LVD Timing Diagram Correction

Result of the May 26/27 meeting
SPI-3R6 Figure 44 & 45 correction
Text Correction
Driver Level Issues

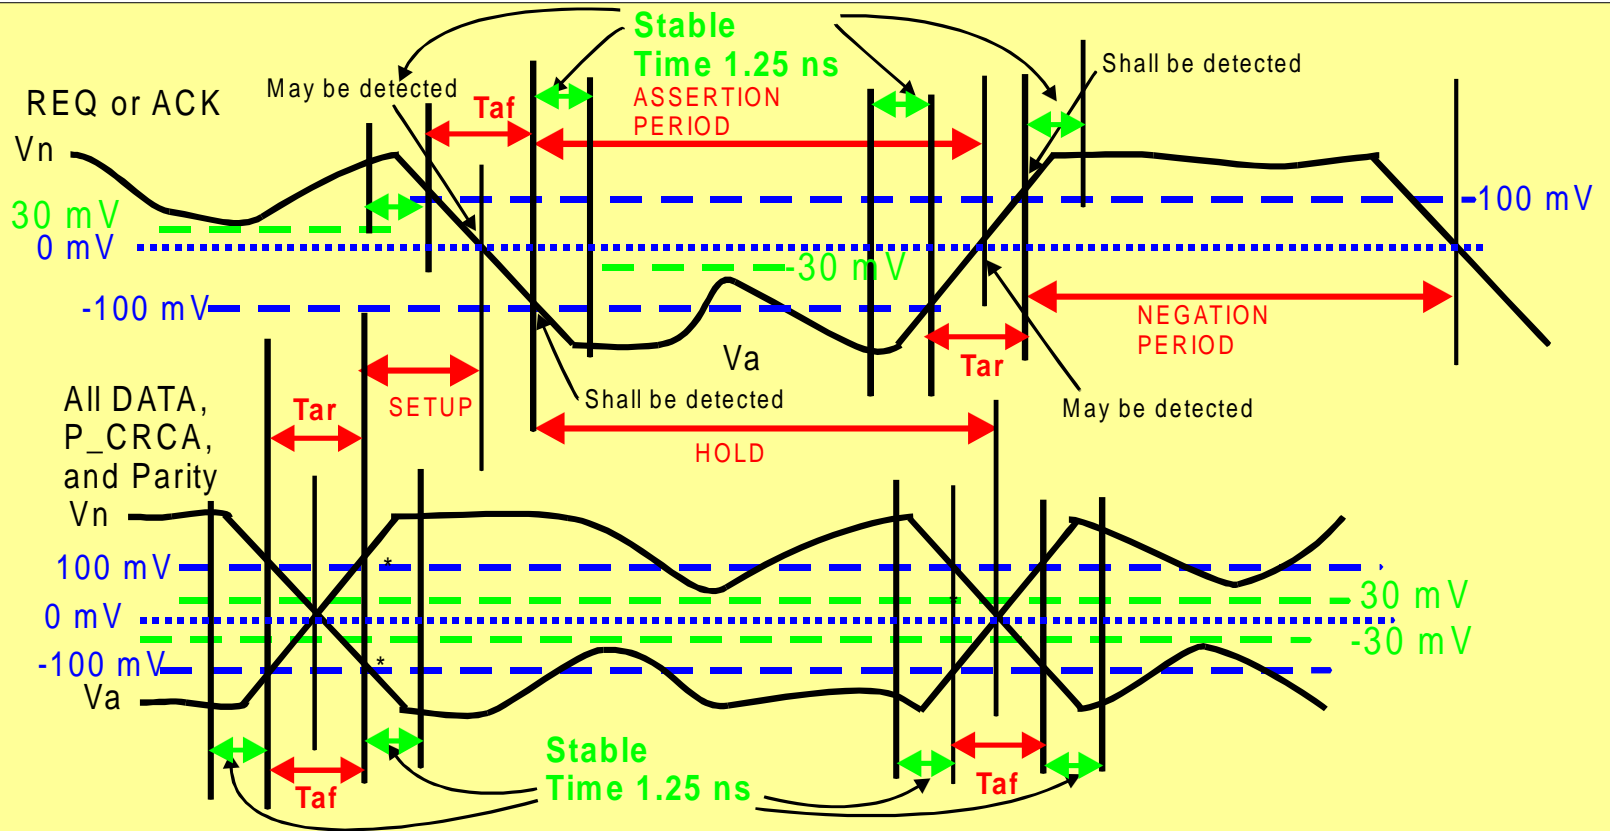
- The receivers require 100 mV to switch fast enough to not have skew problems. This is at the receiving device connector.
- The Receiver requires a maximum of 3 ns rise - fall time from -100 to 100 mV - the waveform in this region -100 and 100 mV, is not defined.
- Notes for Engineers; Receivers simulations should with very fast rise time, rise time goes to 0 and stays there until 3 ns with a fast rise time. Amplitudes from +/- 100 MV to +/- 800 mV should be simulated with the range of rise times. All line will see different wave forms, worst should be simulated against best over Process, Temperature and voltage to insure the receivers will make the skew requirements.

Note: Blue is delete, red is add

-Figure 44

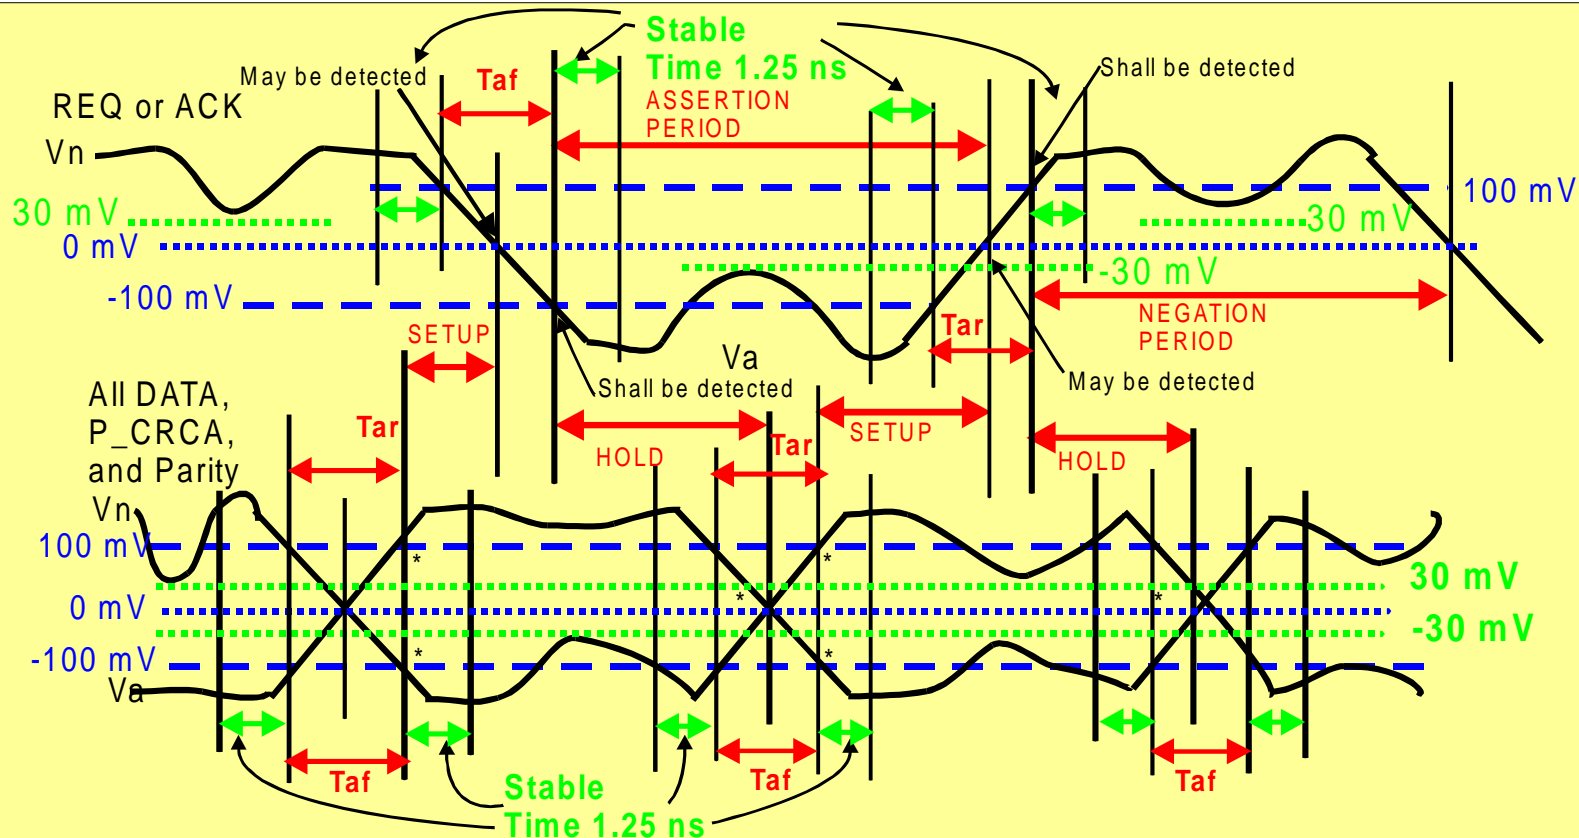
* Use the crossing that yields the shorter SETUP and HOLD Time
 Va or Vn must drive the 100 mV at the leading edge of the transition.
 The signals shall be at least 100 mV during the stable time of 1.25 ns.
 Vn = Negated Signal
 Va = Asserted signal
 Differential voltage signals in all Cases

Taf and Tar must be less than 3 ns and any signal structure while in the Taf or Tar region including slope reversal may occur. (At the receiver)

Proposed changes to the LVD ST Timing Diagrams

-Figure 45

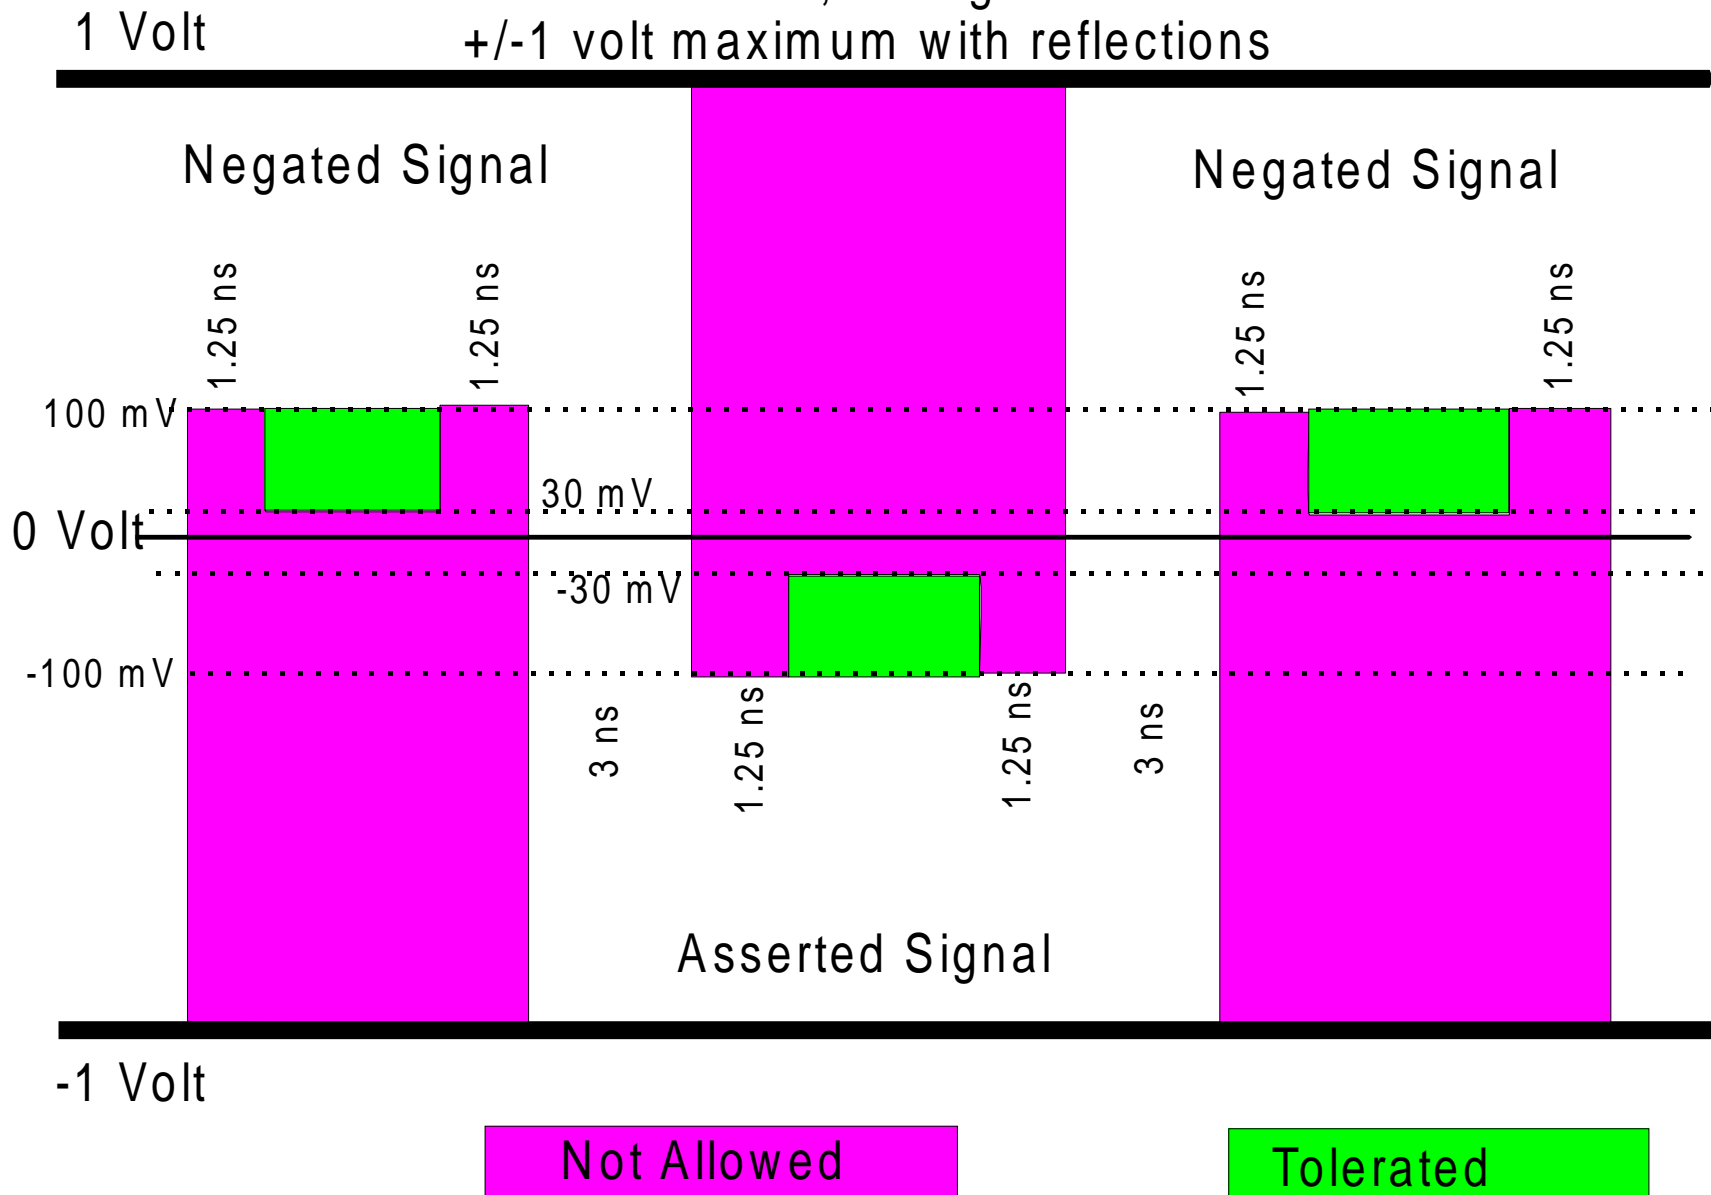
* Use the crossing that yields the shorter SETUP and HOLD Time
 V_a or V_n must drive the 100 mV threshold at the leading edge of the transition.
 The signal shall be at least 100 mV during the stable time of 1.25 ns.
 V_n = Negated Signal
 V_a = Asserted Signal
 Differential voltage signals in all Cases

T_{af} and T_{ar} must be less than 3 ns and any signal structure while in the T_{af} or T_{ar} region including slope reversal may occur.

Proposed changes to the LVD DT Timing Diagrams
